P02	19/05/23	Response to RFI	
P01	29/04/22	Issued for Planning	
Revision Number	Date	Drawn	Details of Issue / Revision
Issues & Revisions

Project Details:
Dalgise
Monkstown

Drawing Title:
Proposed Elevations + Sections - Block A

MKS-RAU-A-ZZ-DR-AR-200	Revision
	P02

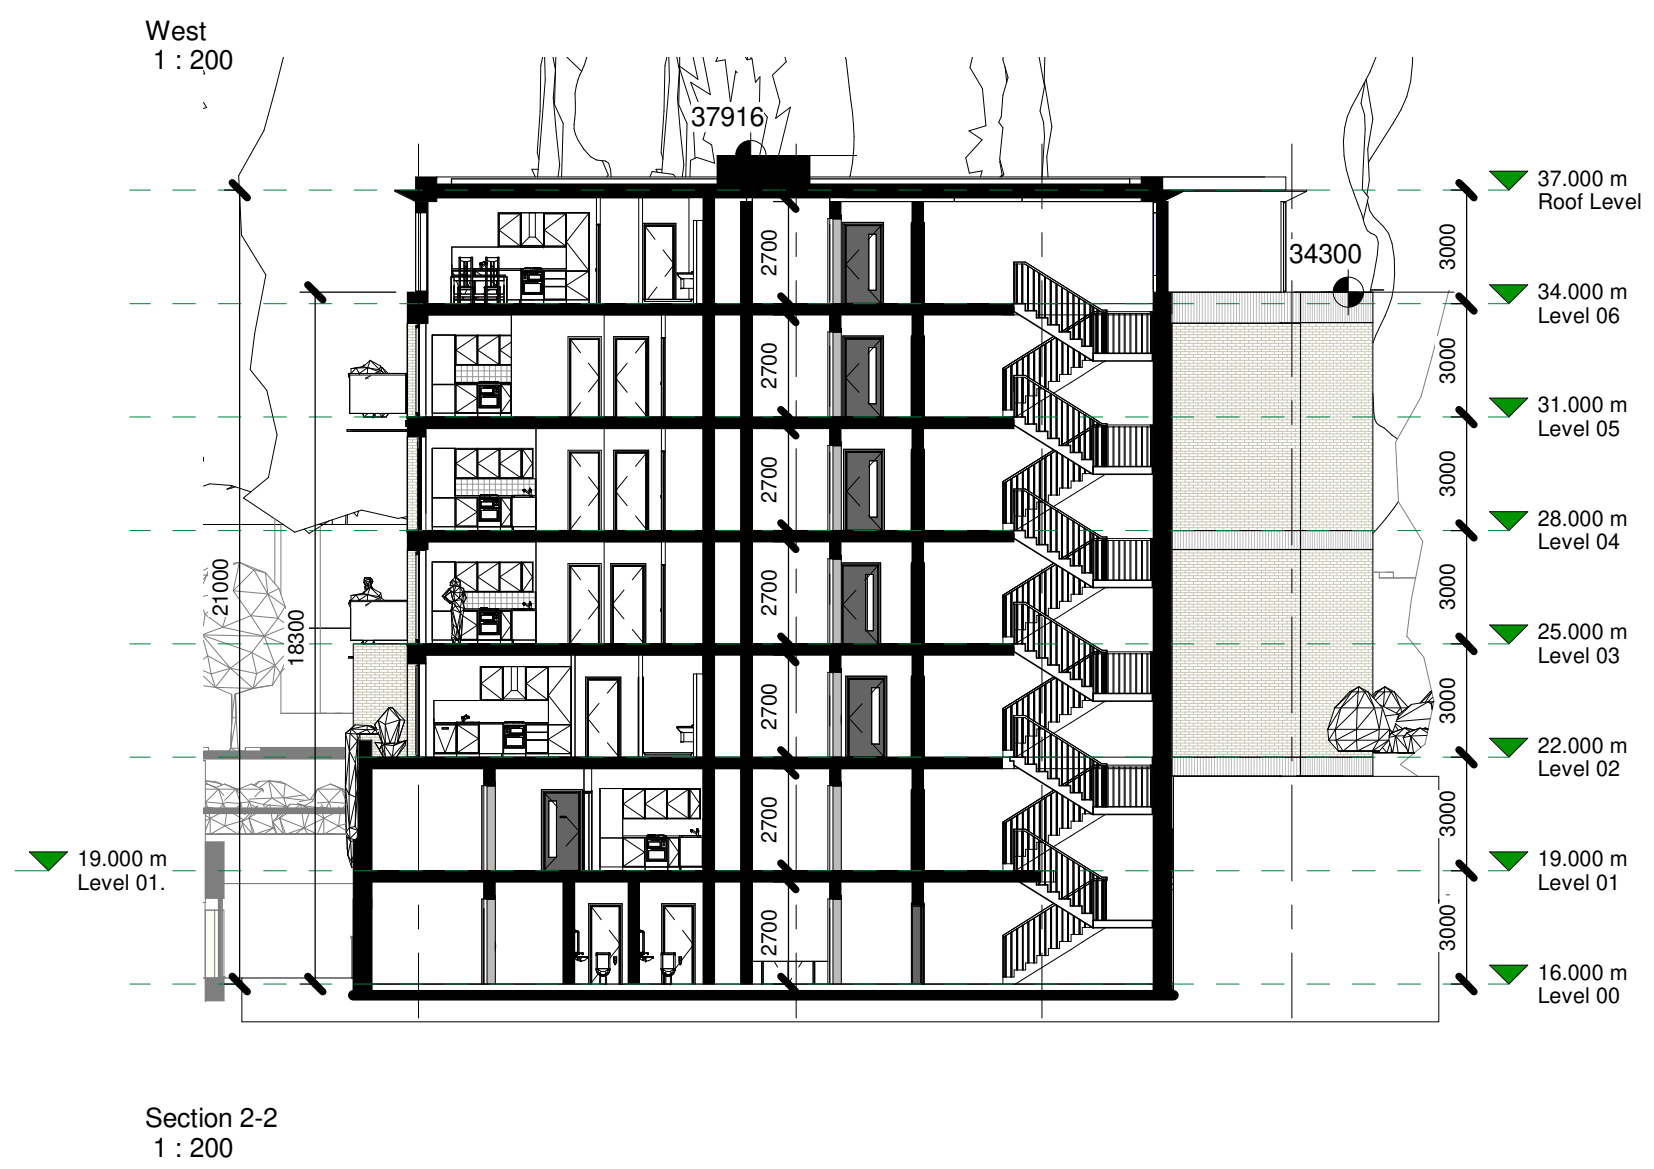
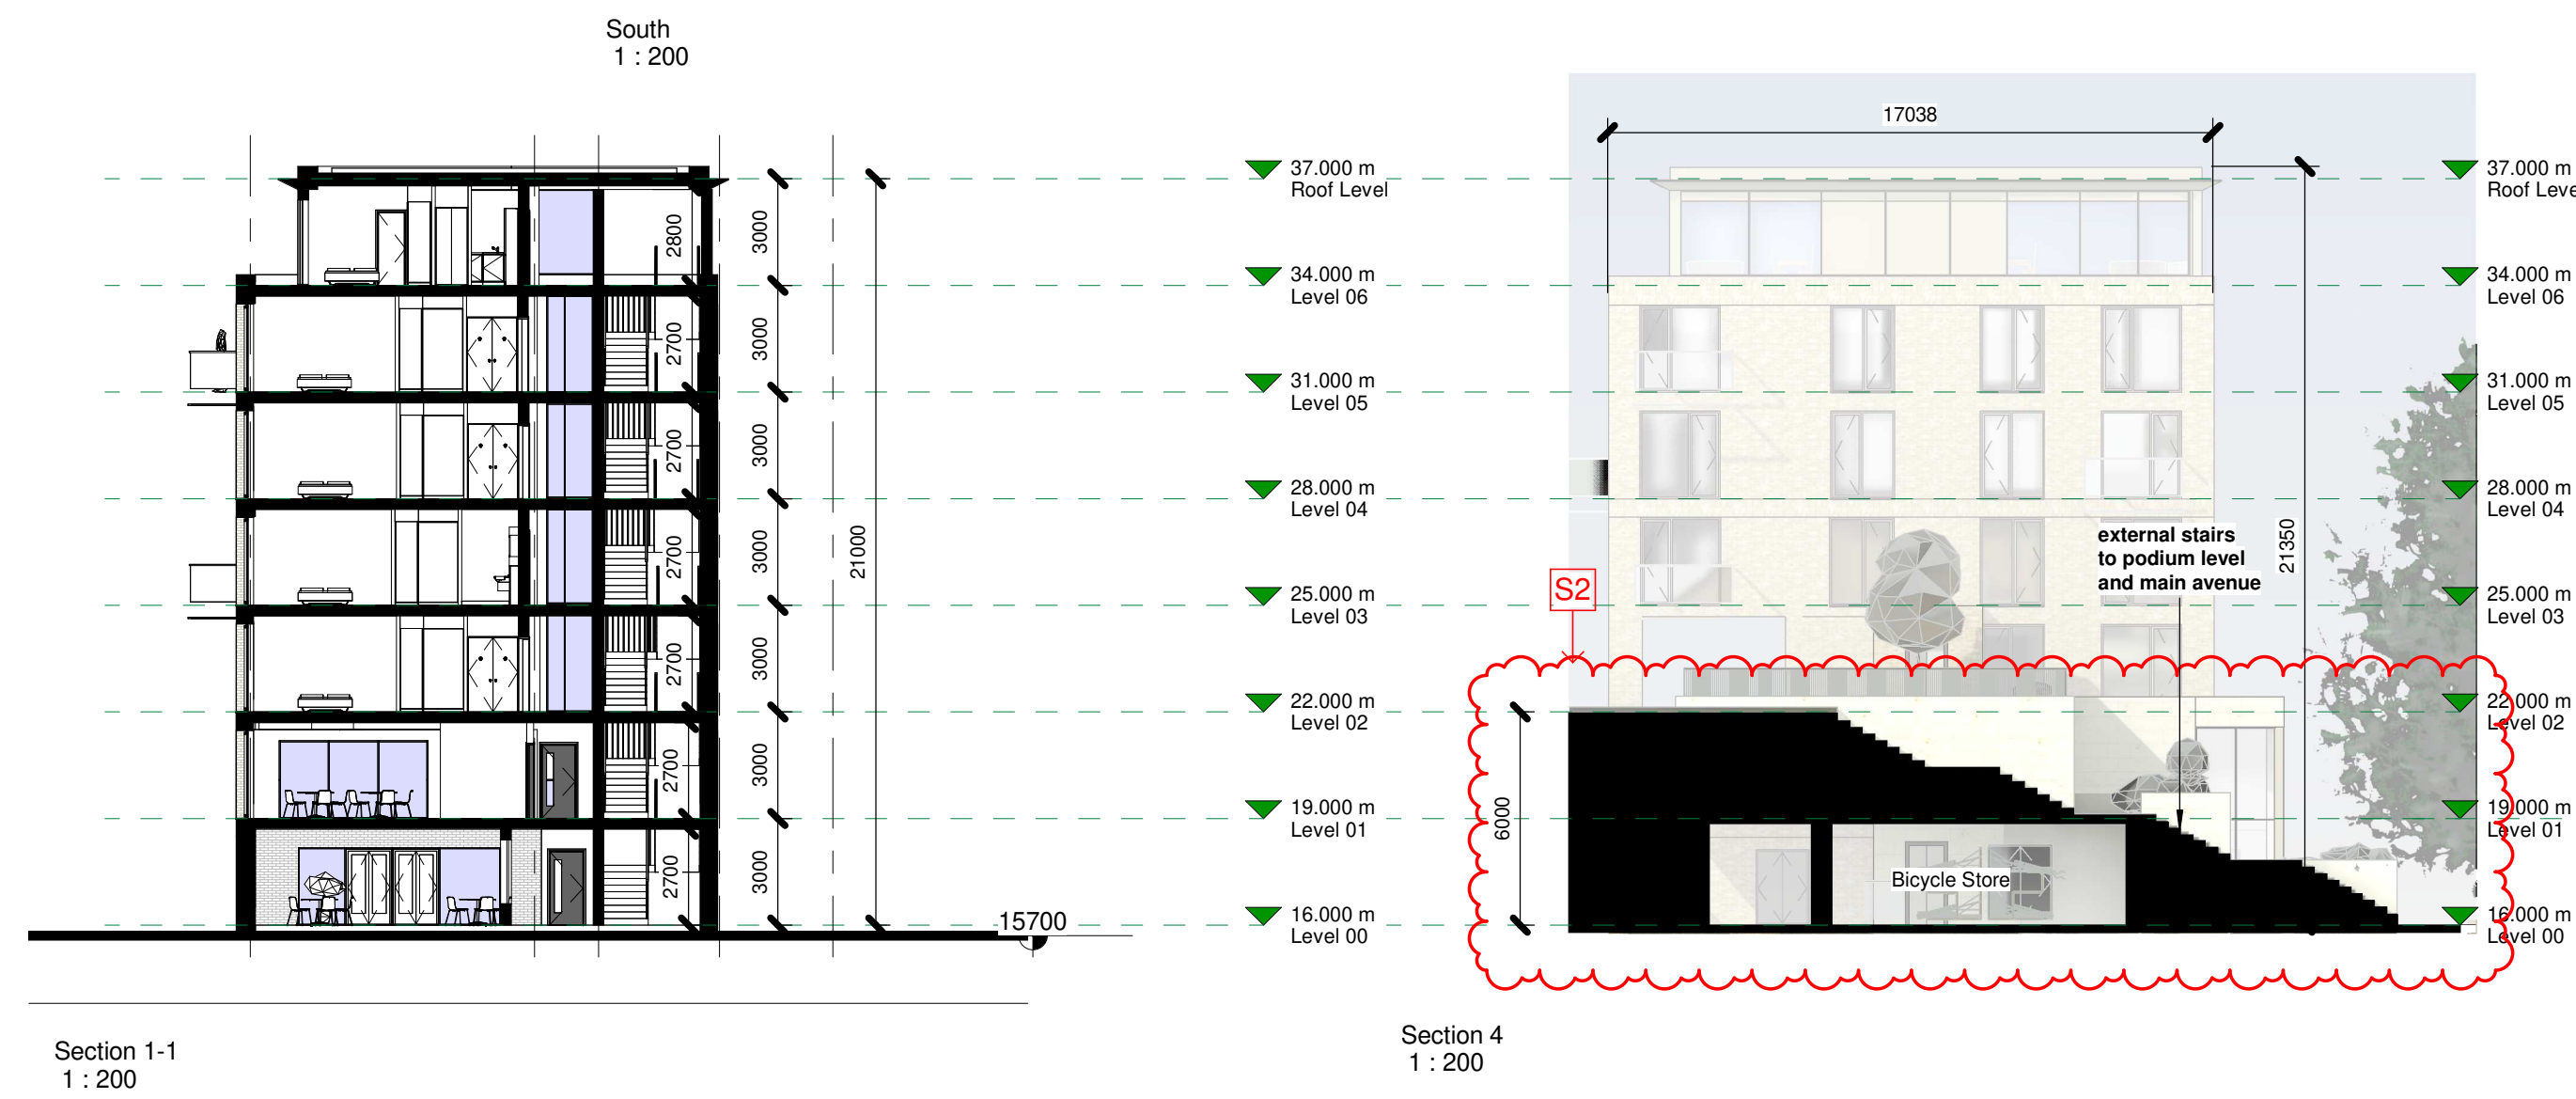
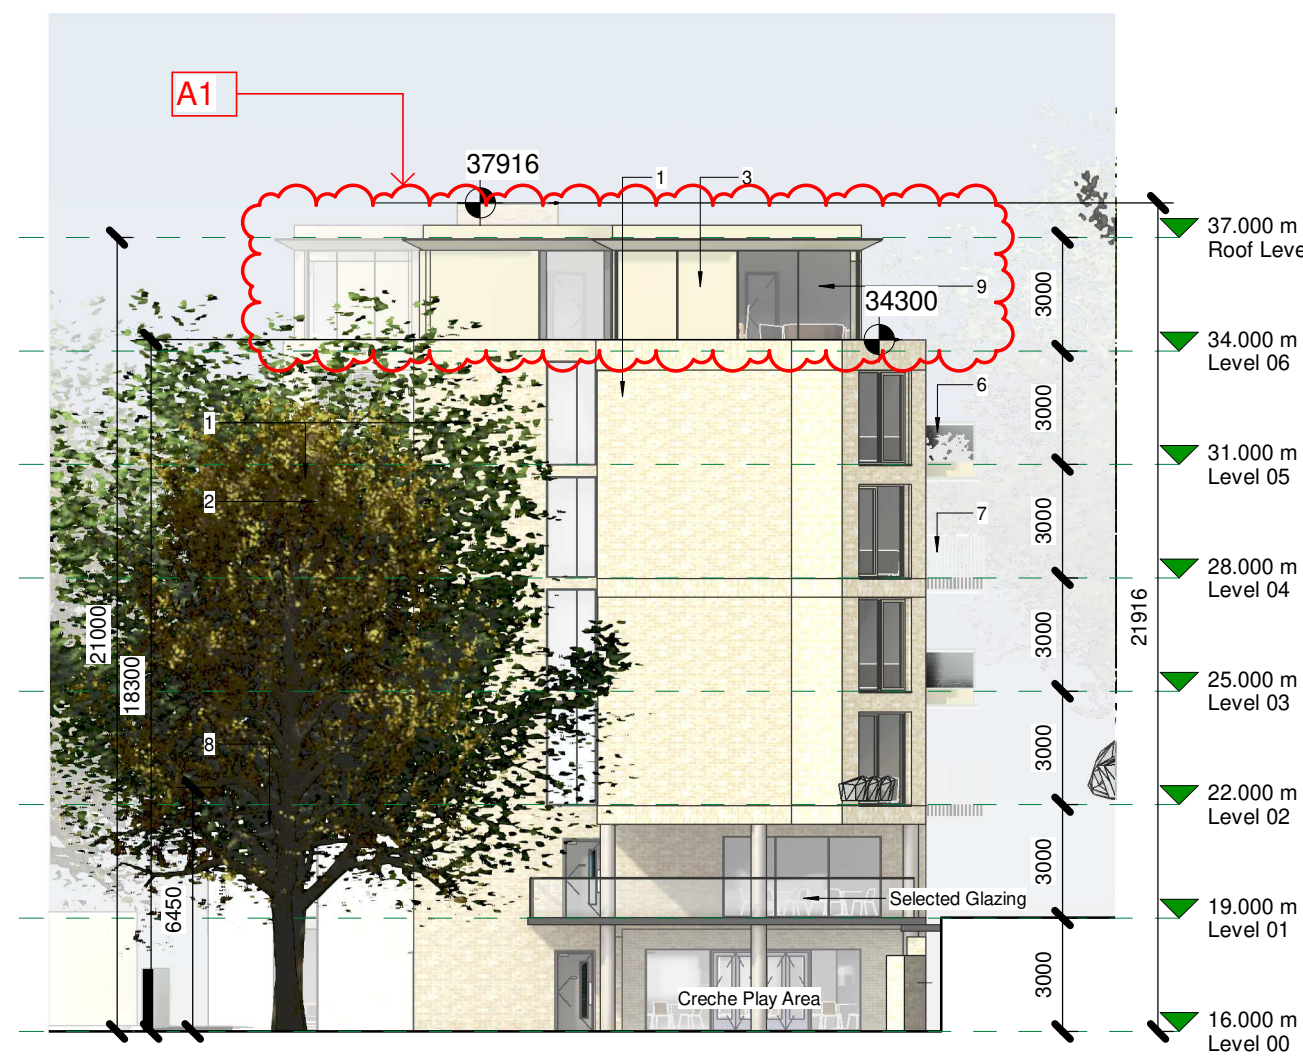
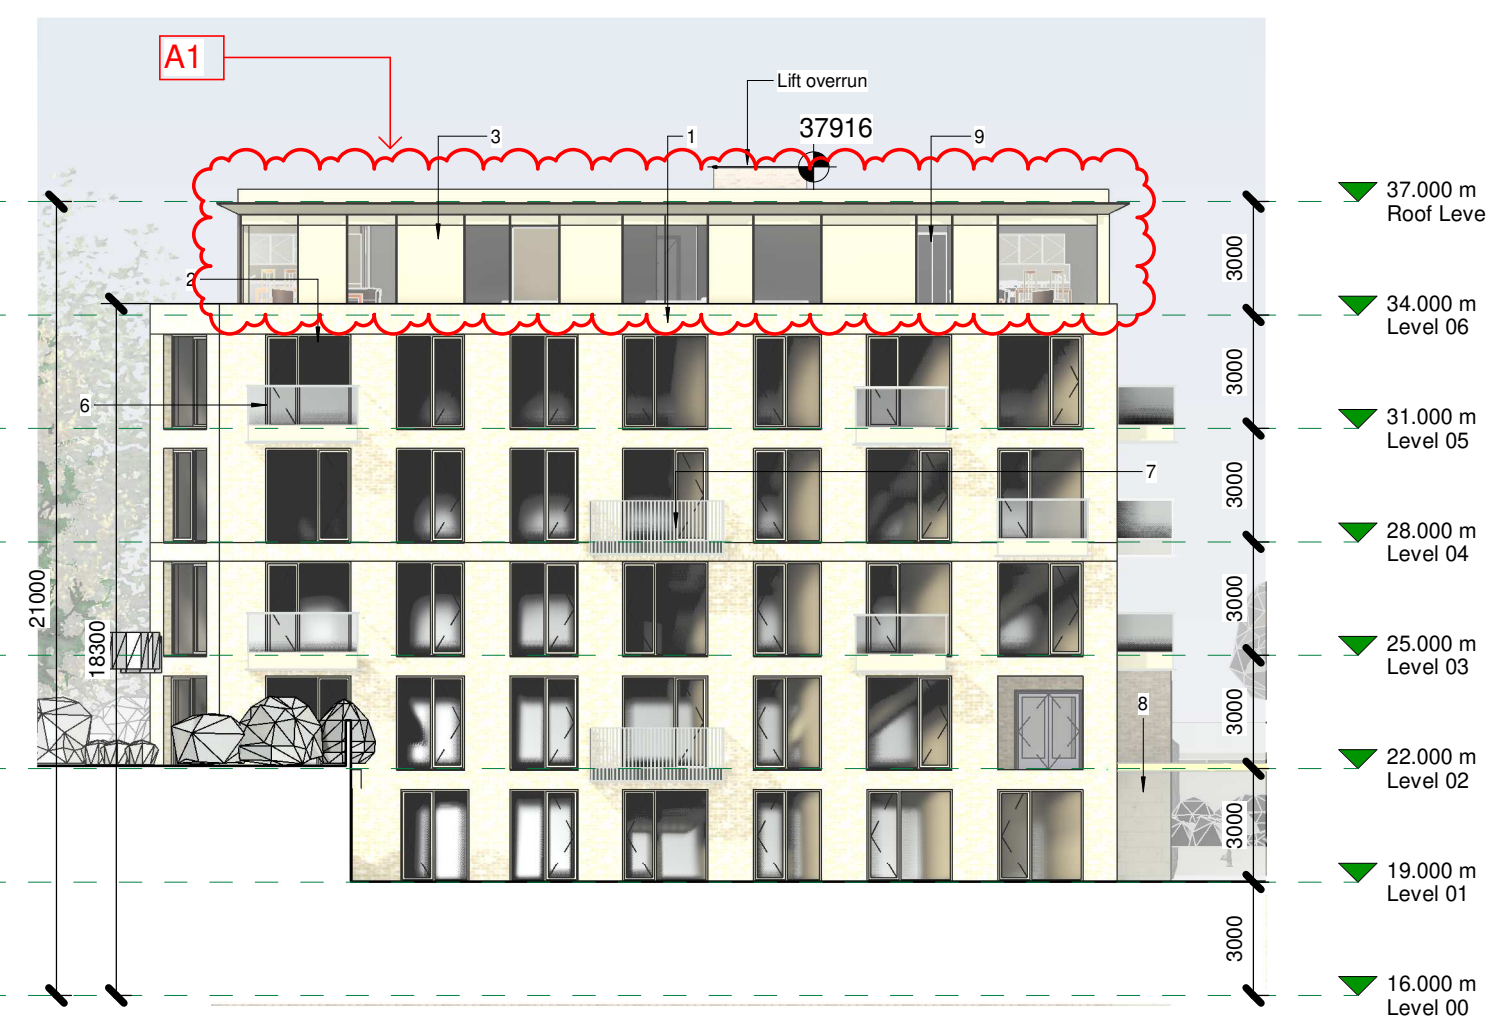
- REVISIONS**
- A1. Tonal Change at Penthouse level.
 - A2. Double height windows changed to single height.
 - A3. Minor alterations to creche layout / elevations.

- S2. Re-alignment of the Basement Car Park Entrance. The Entrance is now located underneath Block B.
